RE: Addendum to the Arboricultural Impact Assessment (December 2019) for 18-20 Sturdee Lane, Lovett Bay.

This letter has been prepared as an addendum to the Arboricultural Impact Assessment (AIA) written by Bluegum in December 2019. The purpose of this letter is to address the changes in the proposed design (S4.55 Modification) that have since been made to reconcile the recommendations of the RFS conditions relating to bushfire protection.

Figure A: SRZ of Trees 95 and 97

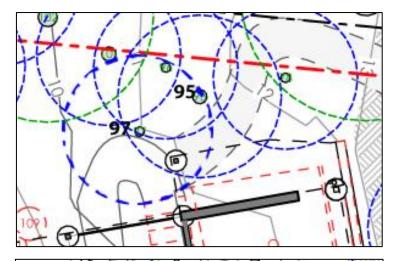
- A new concrete pier to support the concrete deck within the Structural Root Zone of Trees 95 and 97 (Figure A).
- Construction of a low foundation wall along the southern side of the pavilions to enclose sub-floor areas to create a fire-proof structure. This will be required within the Structural Root Zone of Tree 81 (Figure B).

The position of the concrete pier near Trees 95 and 97 can be flexible to allow it to be spaced clear of structural tree roots. Excavation for this pier must be undertaken with care using hand tools. The final position must be adjusted as necessary to avoid contact with tree roots greater than 40mm diameter.

Figure C: Detail of root bridge within the low foundation wall footings.

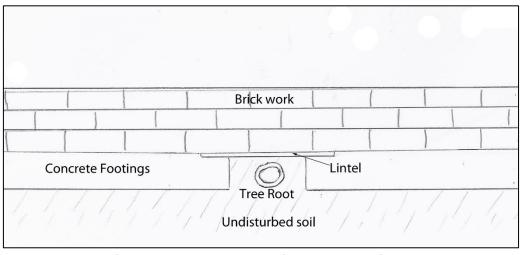
The footings for the low foundation wall within a 2.0m radius of Tree 81 must be undertaken with care using hand tools. Any tree roots greater than 40mm diameter must be retained and bridged using a steel or concrete lintel as detailed in Figure C below.
